Ku-ring-gai Council Submission

**Proposed Residential Flat Development
1, 1A & 5 Avon Rd, 4 & 8 Beechworth Rd & 1 Arilla
Rd, Pymble**

MP08_0207 and MP10_0219

February 2011

Site survey:

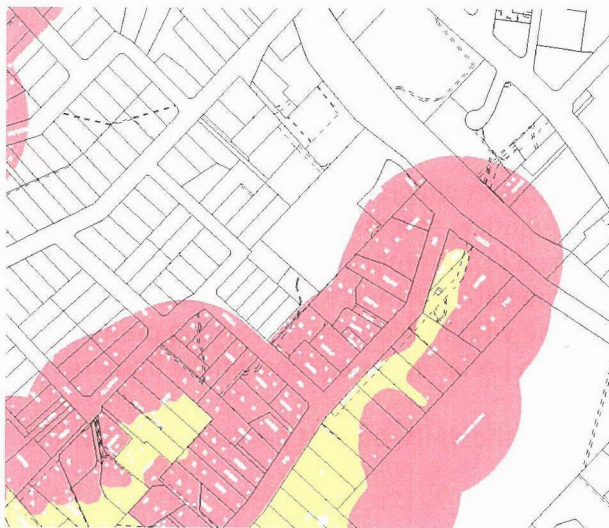
- Fails to accurately identify the trees on the site;
- Fails to identify the additional bend in the riparian zone at the top of the site.
